LAUNDRY BLOCK - DPD PROJECT: EAST # 3011607 / WEST #3011606 / LAUNDRY BUILDING #3011522

Design Review Board Recommendation Meeting: April 20, 2011

DEPARTURE REQUESTS - Upper Level Setbacks H.1

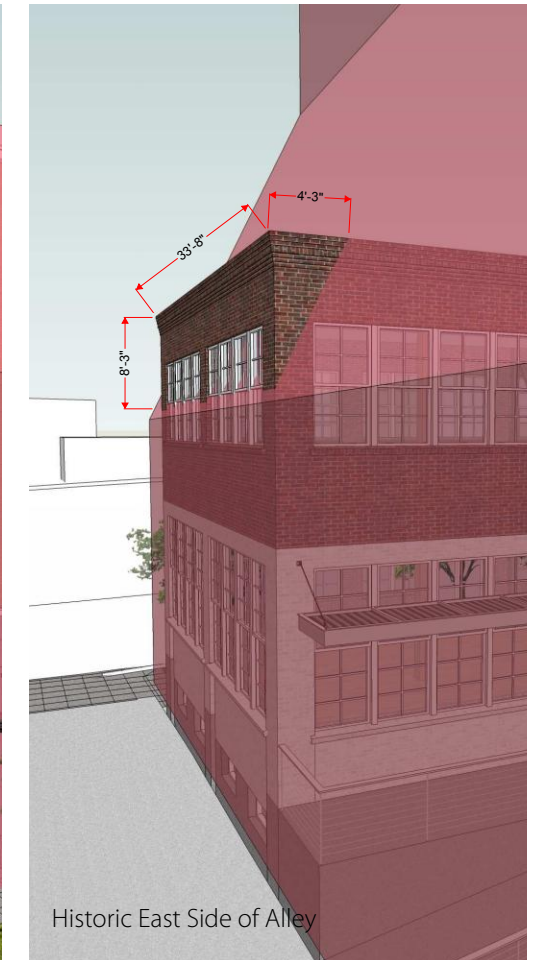
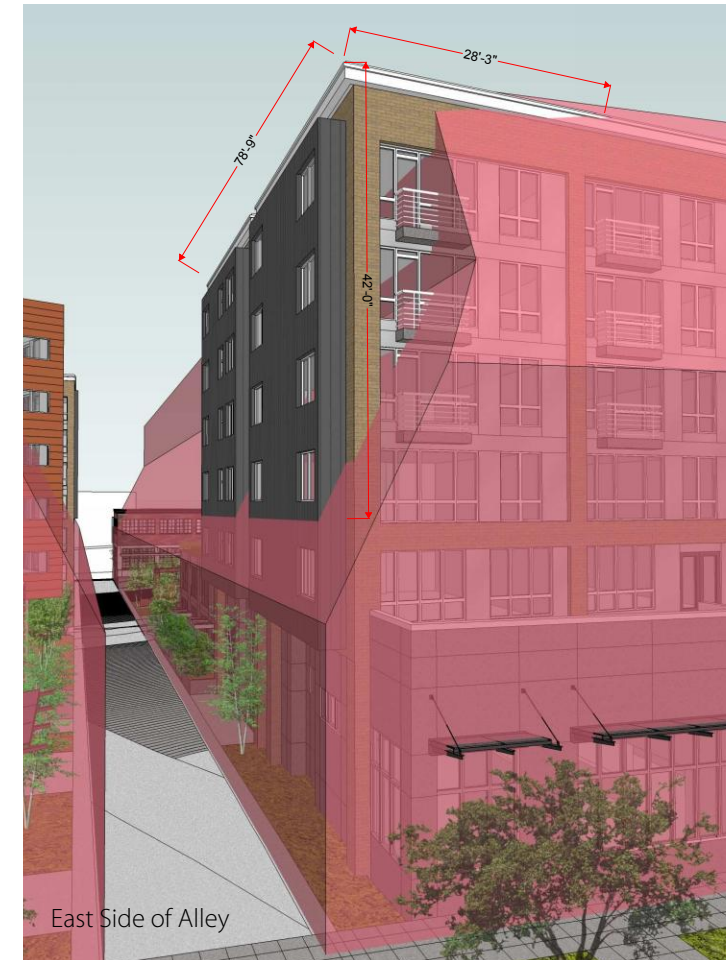
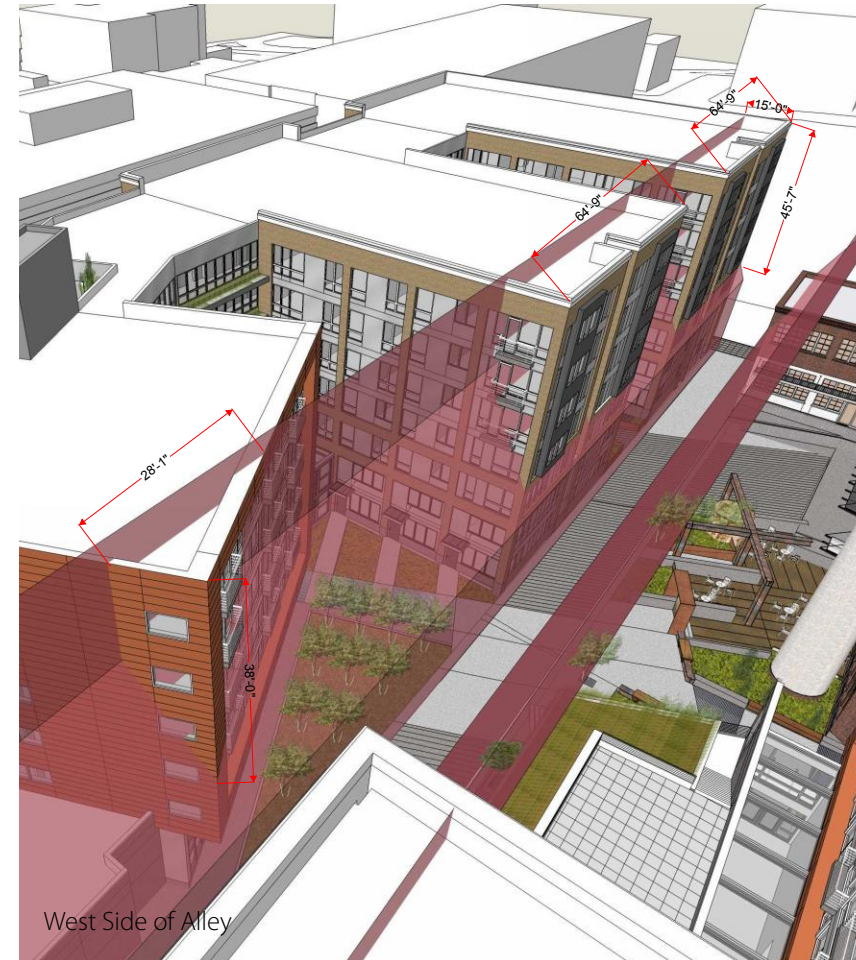
REQUIREMENT	REQUEST	JUSTIFICATION	DRB COMMENTS
<p>Upper Level Setbacks SMC 23.48.012</p> <p>Upper level setbacks are required along Harrison Street above 45'-0".</p> <p>Upper level setbacks are required for facades facing alleys for any portion of the structure greater than 25'-0" in height.</p>	<p>To allow the top 2 floors to extend into the setback along Harrison Street and the top 4 floors to extend into the setback along the alley.</p>	<p>The project sets back several feet at sidewalk level to allow activity to spill out onto portions of the sidewalk. In addition, the project is voluntarily setting back the upper floors along Harrison to preserve views to and from St. Spiridon Cathedral.</p>	<p>The Board supported the request for this departure as shown at the EDG meeting on 10/6/10.</p>

H.2 DEPARTURE REQUESTS - Minimum Facade Height

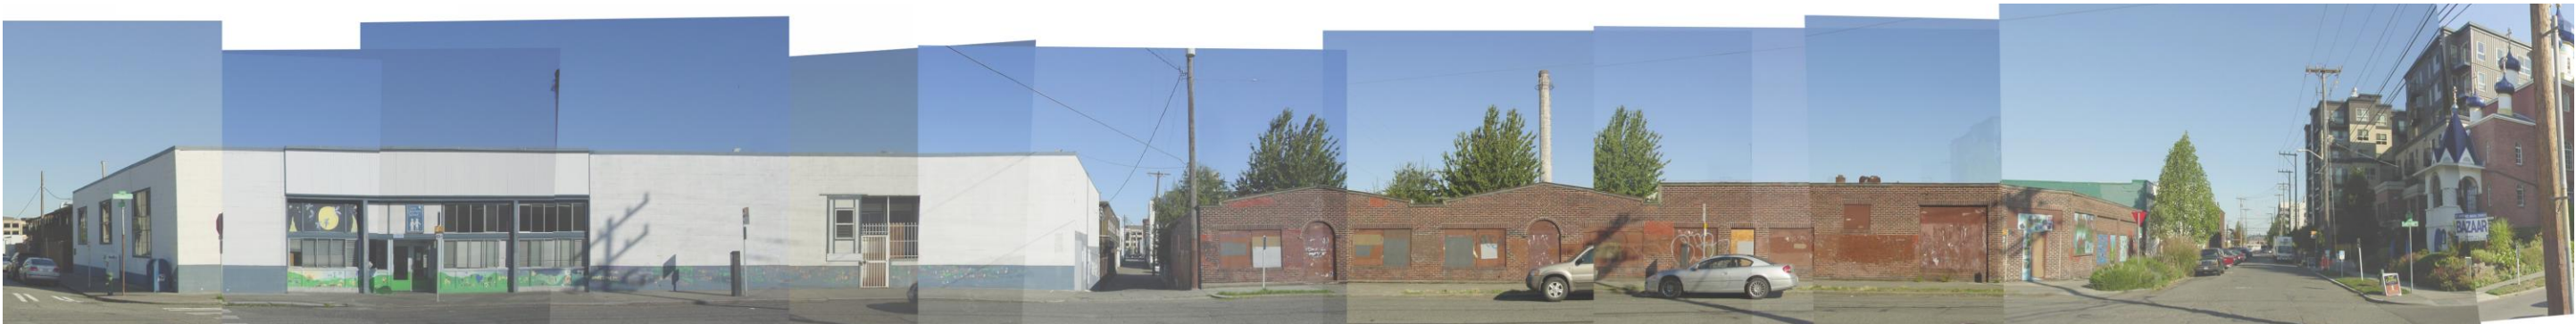
REQUIREMENT	REQUEST	JUSTIFICATION	DRB COMMENTS
Facade Height SMC 23.48.014.B.2 Class 2 Pedestrian streets require a minimum facade height of 25'-0"	To allow portions of the new building facades along Harrison Street to be between 21' - 25' tall.	The southeast building (10SE) is intentionally setting back the upper floors to allow visual clearance to and from St. Spiridon Cathedral. Additionally, to avoid pinching the alley with two tall buildings, the east side of the west building pulls back from the alley and the street.	This request was not known at the time of the EDG presentation.

DEPARTURE REQUESTS - Facade Transparency and Blank Facade H.3

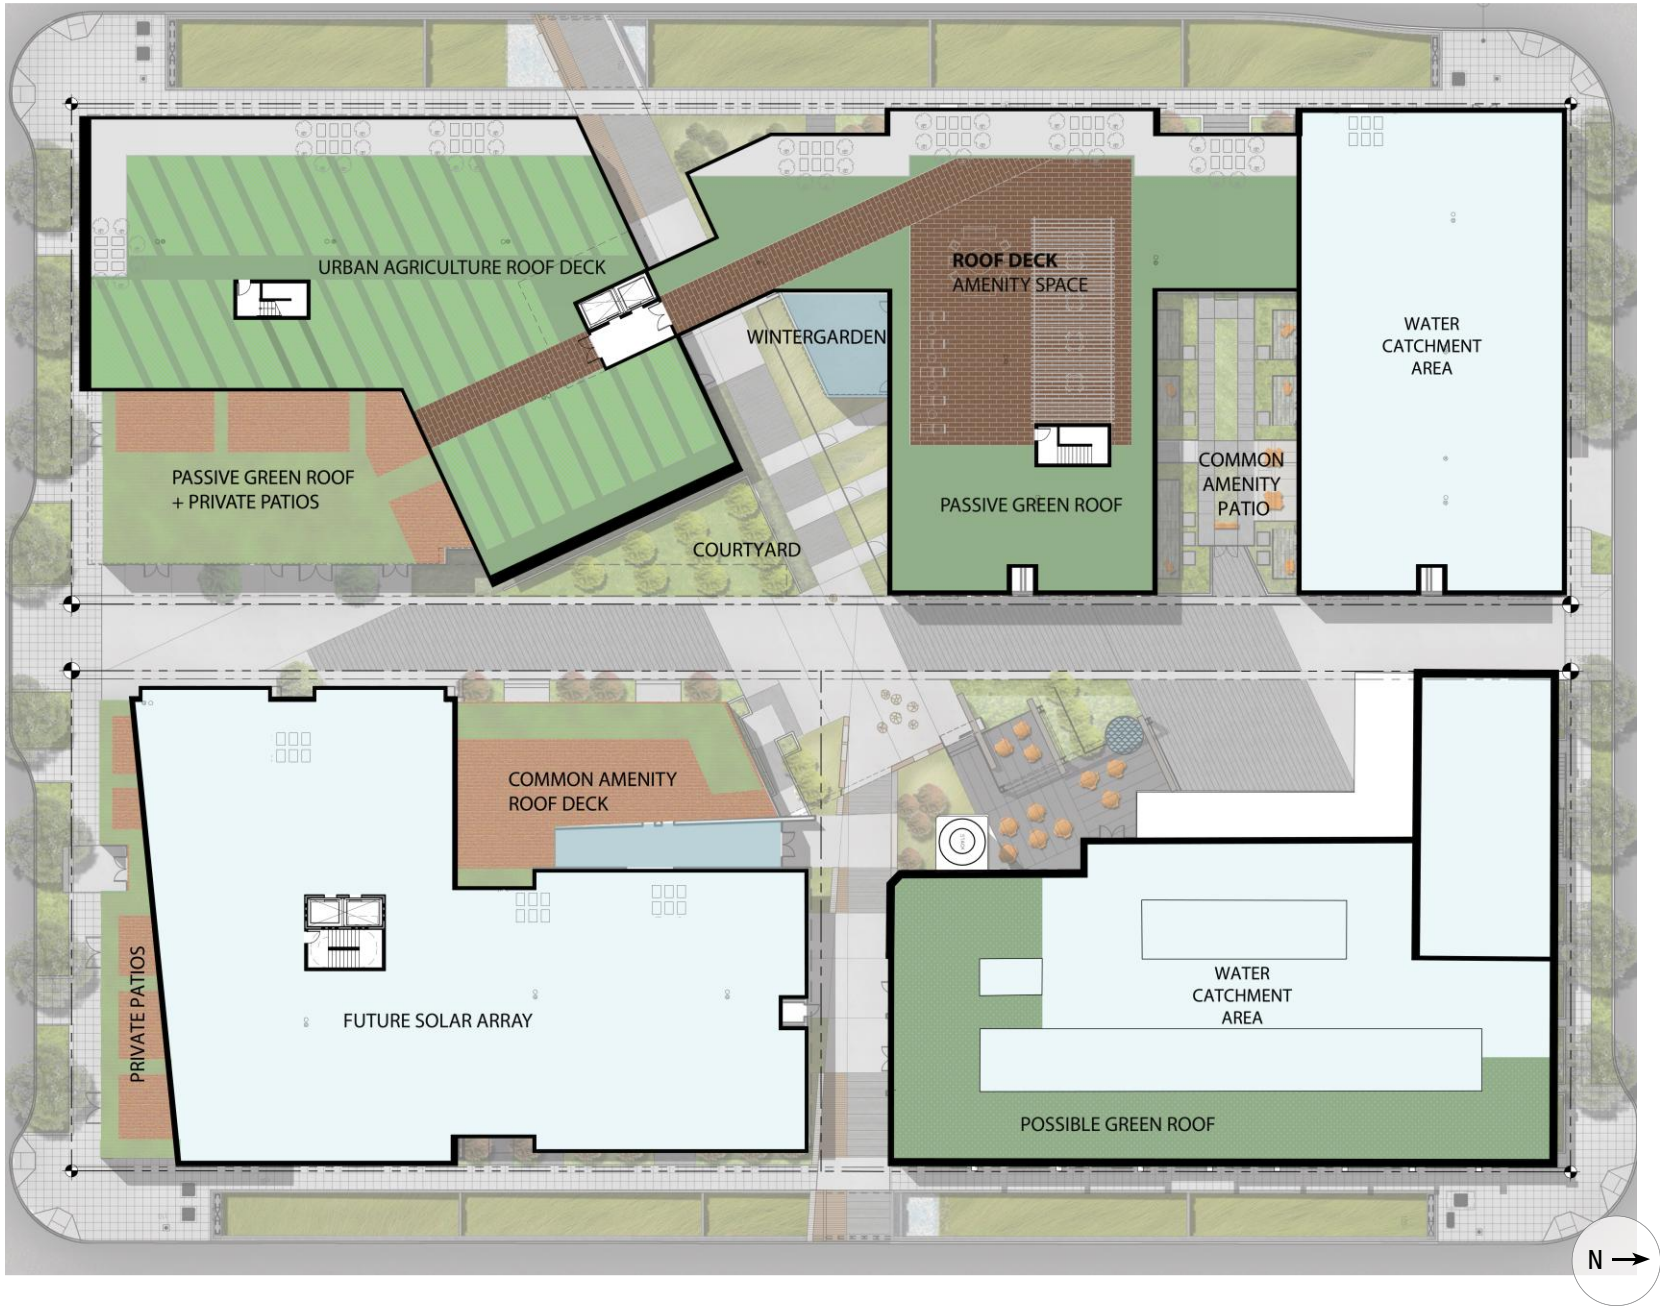
REQUIREMENT	REQUEST	JUSTIFICATION	DRB COMMENTS
Blank Façade SMC 23.48.018.A.1 On Class 2 pedestrian streets the maximum width for a blank façade is 15' wide (exclusive of garage entries)	Allow a 16'-9" wide blank façade along Republican Street.	This blank façade is set back from the property line by 10'-0" to allow pedestrians along the alley and Republican street a better view of the cars entering and exiting the parking garage. The project is also planning to provide a window into the cistern for people to see the water collection levels.	This façade was not developed at the time of the EDG presentation.

REQUIREMENT	REQUEST	JUSTIFICATION	DRB COMMENTS
Façade Transparency SMC 23.48.018.A.1 On Class 2 pedestrian streets a minimum of 60% of the façade must be transparent between 2" and 8' above grade.	Allow a reduction in transparency along Republican Street from 60% to 48.8%	The easternmost portion of the opaque façade is set back from the property line by 10'-0" to allow pedestrians along the alley and Republican street a better view of the cars entering and exiting the parking garage.	This façade was not developed at the time of the EDG presentation.

H.4 DEPARTURE REQUESTS - Residential Amenity Space

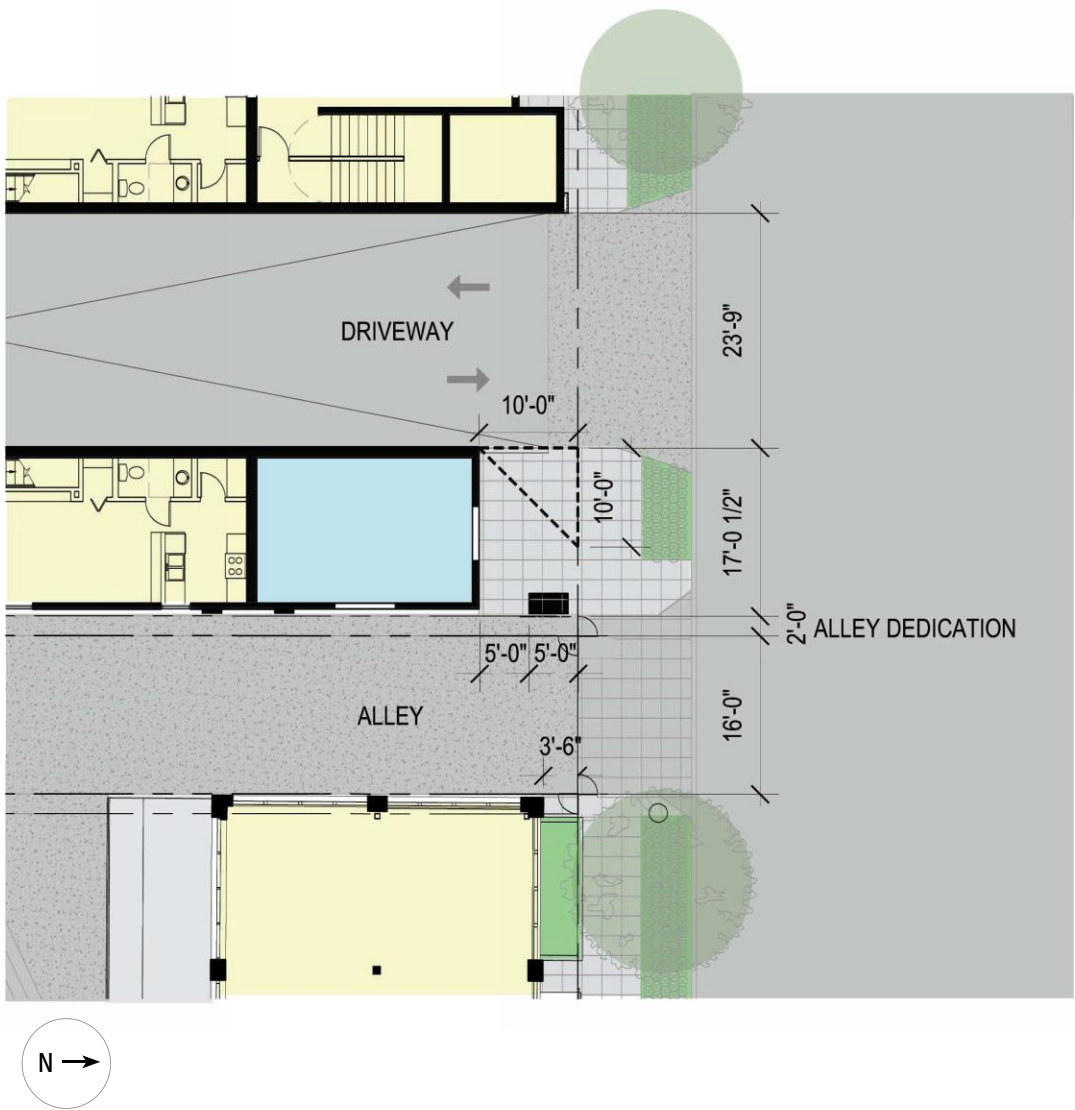
REQUIREMENT	REQUEST	JUSTIFICATION	DRB COMMENTS
Residential Amenity Area SMC 23.48.020 Residential amenity area =5% of the gross residential square footage must be provided.	Allow the residential amenity area to be accommodated for the project as a whole rather than requiring a proportional division by building.	We are not requesting to reduce the quantity of residential amenity area. We would like to consolidate the amenities to serve the entire site, rather than the individual buildings. Amenity spaces to include a large roof deck on top of 10W, a smaller roof deck at level 3 of 10SE, as well as a grade level courtyard, amenity patio and winter-garden.	The Board supported the request for this departure as proposed at the EDG meeting on 10/6/10.
